Access Compliance Report

Public Rights-of-Way

Intersection ID: 10033047	Main Street: NORFOLK_AV	Cross Street: N/A	Location: NW
ADA ID: 5DB078E3913B	Ramp Type: Perp	Initial Pass/Fail: Fail	Overall Compliance: No
		Severity Score: 12.5

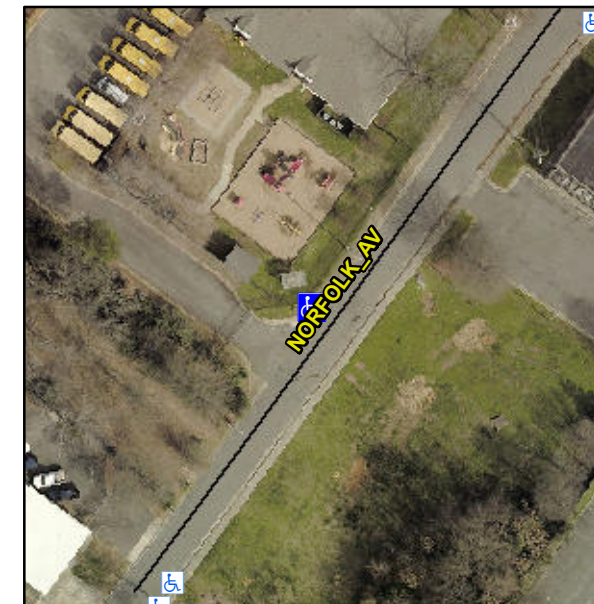
Not Found, R304.5.3

Compliance	Description	Data	Compliance	Description	Data
N/A	Ramp Length (in)	48.0	Yes	Ramp Slope (%)	6.4
Yes	Ramp Width (in)	48.0	No	Ramp XSlope (%)	6.8
N/A	Flare Type LT	N/A	N/A	Flare Type RT	N/A
N/A	Flare Slope LT (%)	N/A	N/A	Flare Slope RT (%)	N/A
N/A	Flare Traversable LT?	N/A	N/A	Flare Traversable RT?	N/A
N/A	Landing Length (in)	N/A	N/A	DWS Provided?	N/A
N/A	Landing Width (in)	N/A	N/A	DWS Contrast?	N/A
N/A	Landing Slope (%)	N/A	N/A	DWS Length (in)	N/A
N/A	Landing X Slope (%)	N/A	N/A	DWS Full Width?	N/A
N/A	Landing Curb? (Y/N)	N/A	N/A	DWS Offset (in)	N/A
N/A	Shared Landing?	N/A			
N/A	Gutter Ponding?	N/A	N/A	Gutter Slope (%)	N/A
N/A	Gutter Lip Ht (in)	N/A	N/A	Gutter X Slope (%)	N/A
N/A	Painted X Walk1?	No	N/A	Painted X Walk2?	N/A
	X Walk 1 Direction	To SE		X Walk 2 Direction	N/A
N/A	X Walk 1 Width (in)	N/A	N/A	X Walk 2 Width (in)	N/A
	X Walk 1 Slope (%)	5.1		X Walk 2 Slope (%)	N/A
	X Walk 1 X Slope (%)	4.7		X Walk 2 X Slope (%)	N/A

Remove & Replace Entire Ramp.
